PLANNING DEPARTMENT STAFF REPORT AND FINDINGS:

THE RESERVE, PHASES 3–5 – Preliminary Subdivision Approval (File: SUB 20–052)

TENTATIVE SUBDIVISION PLAN- PROPOSED LAYOUT
THE RESERVE AT JUNCTION CITY PHASE 3
NW 1/4 SECTION 31, TOWNSHIP 13 SOUTH, RANGE 4 WEST AND
NE 1/4 SECTION 26, TOWNSHIP 13 SOUTH, RANGE 5 WEST, W.M.
JUNCTION CITY, LANE COUNTY, OREGON
Date Prepared: JUNE 07, 2023

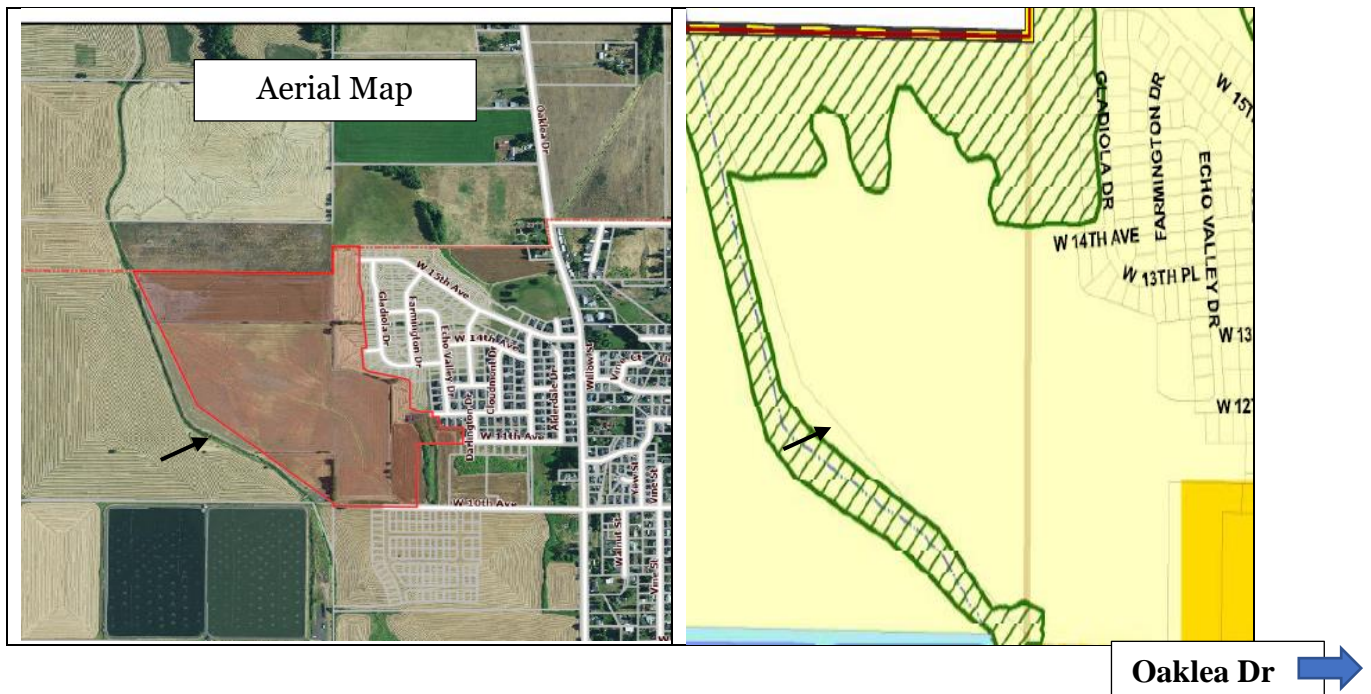
Finding #17: The proposed streets intersect at right angles: See Grading and Drainage Plans. Intersections shall be designed so that no jog is dangerous to the traveling public. The applicant states there are no intersection jogs and mid-block intersections are greater than 100 feet from each other as measured from their respective rights-of-way. However, the City Engineer noted that in the initial preliminary plan, the connection for W 14th Place and West 14th Avenue to Reserve Phase 2 did not meet the required 200' radius minimum horizontal curve per Section 1.14.b of the PWDS. The preliminary plan has been revised to address this issue.

It should be noted that the extension of W. 15th is not connected to its parent street and takes a jog south. In order to address connectivity, the applicant has created a pedestrian path between the extension of W. 15th Avenue and Hibiscus Drive. Staff has raised the question of whether the extension of W. 15th Avenue should actually be named W. 15th Place. This is because if the property to the north is brought into the urban growth boundary, it would make sense to extend W. 15th Avenue to serve that area.

Finding #19: The preliminary plan proposes four (4) dead-end streets that end in a manner to allow their future extension. The terminuses of W 13th Avenue, W 14th Place and W 15th Avenue all connect to the remainder of Tax Lot 10900, which is owned by the applicant. The terminus of Jasmine Drive provides an entry point from the north end of the subject property, which is currently outside of the city limits. The City Engineer notes that a projection of the profile of streets that may be extended or reconstructed in the future are required by Section 1.10.H.2.d of the PWDS.

Finding #20: The preliminary plan proposes two cul-de-sacs; one in Phase 3 off of 12th Avenue and one in Phase 4, at the east end of W 15th Avenue. The latter cul-de-sac serves eight lots and the Tract D stormwater pond. Each of the cul-de-sacs have a circular end and a minimum diameter of right-of-way width (40–50 feet) and paving width (28–36 feet). The cul-de-sac at the end of W 15th Avenue has been redesigned to meet Oregon Fire Code access standards per OFC Appendix D103.4.

Finding #21: With the exception of W 15th Avenue, all streets which bear the names of existing streets are in alignment with the existing named streets. The Planning Commission must determine whether W 15th Avenue in Phase 4 is the best name for that street as if the property north of Phase 4 is brought into the urban growth boundary it would make sense to extend W. 15th Avenue to serve this property. All proposed streets that run north-south are in alphabetical order, running from east to west.
